Record of Decision
Morse Industrial Corporation Site
Operable Unit No. 3
State Superfund Project
City of Ithaca, Tompkins County, New York
Site Number 755010

October 2010

Responsiveness Summary

Figure 4
Conceptual Site Model
OU No.3
Emerson Power Transmission
Ithaca, N.Y.

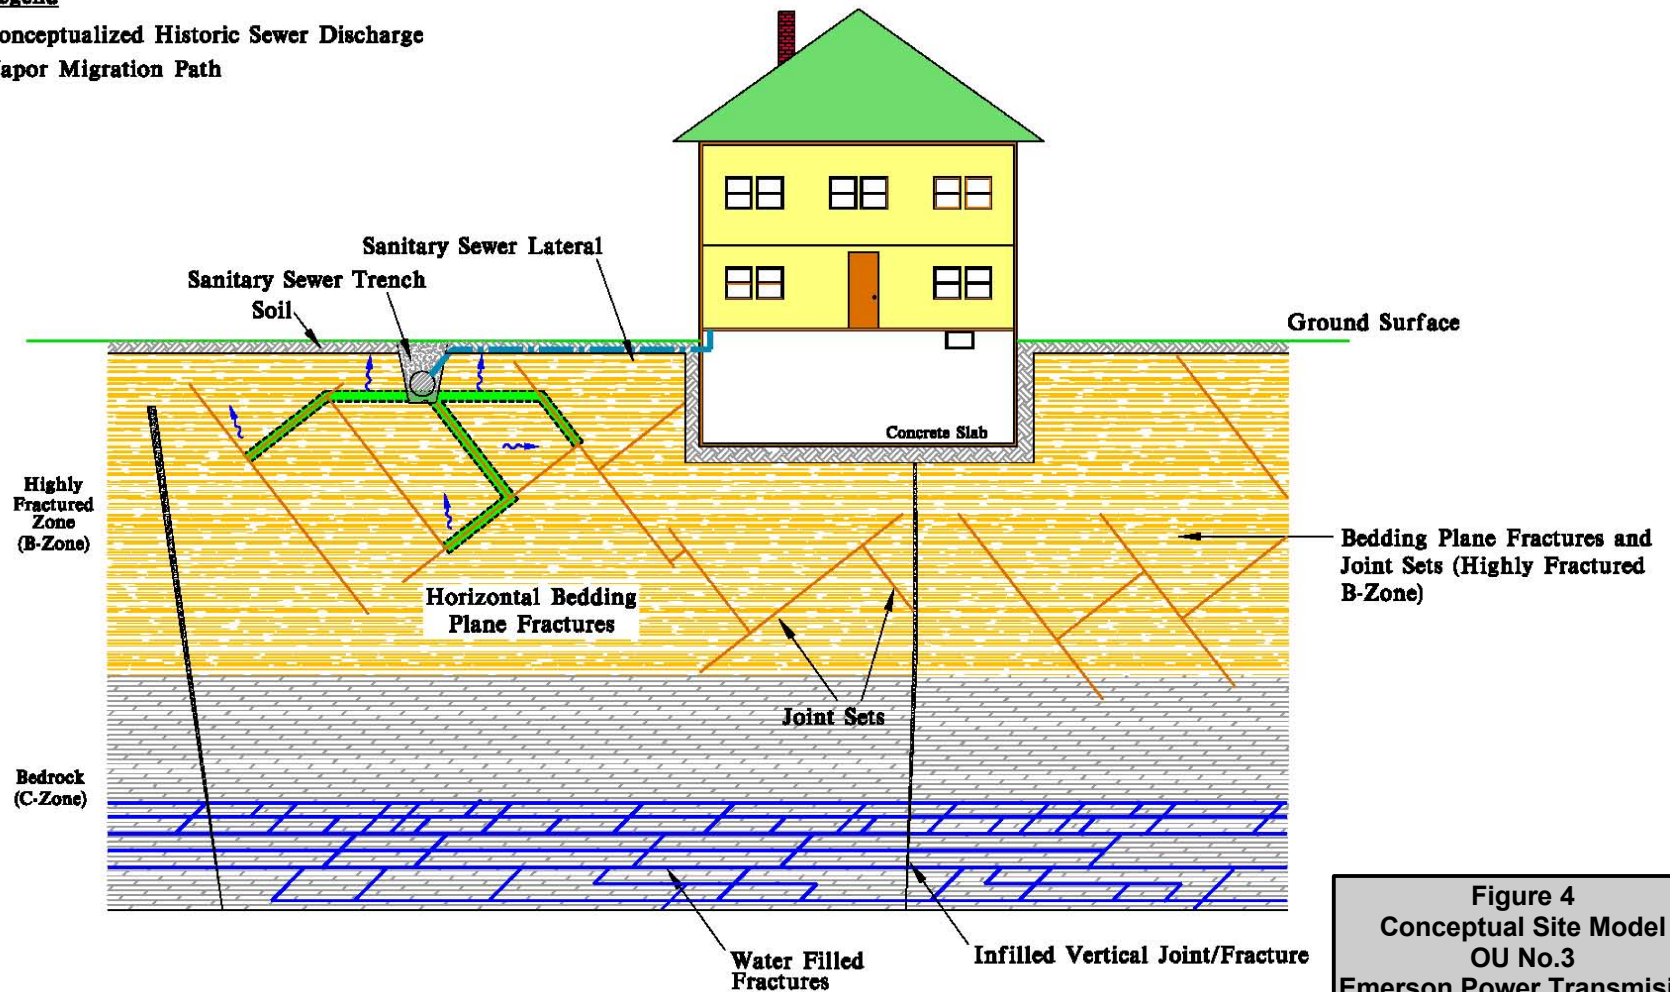
Item 2, bullet 3, states “Initial soil vapor intrusion assessments of private residences and public structures (Phases I through V, Figure 4) completed in March 2007.” Since this refers to the indoor air sampling phases conducted in OU No. 3, Figure 3 (Vapor Intrusion Investigation Phases) should be referenced rather than Figure 4 (Conceptual Site Model).

Paragraph one, line one, refers to discharges to the “municipal sewer system”, whereas, Section 2.2 previously referred to discharges to the “sanitary sewer system.” To be consistent, Section 5.1.2 should be revised to indicate “sanitary sewer system.” Line 12 in the same paragraph discusses the conceptual model for vapor transport in the subsurface and references Figure 3 (vapor intrusion investigation phases). Figure 4 should be referenced as it illustrates the conceptual site model.

Paragraph five, line one, under subheading “Soil Vapor Intrusion,” references Figure 4 which shows the conceptualized historic sewer discharge to the subsurface. As line one is discussing the five phases of indoor air sampling conducted between the fall of 2004 and winter of 2006/2007, it would be more accurate to reference Figure 3 which delineates the five sampling phases.

RESPONSE 11: The text has been modified accordingly.

Paragraph 5: The text has been modified accordingly.
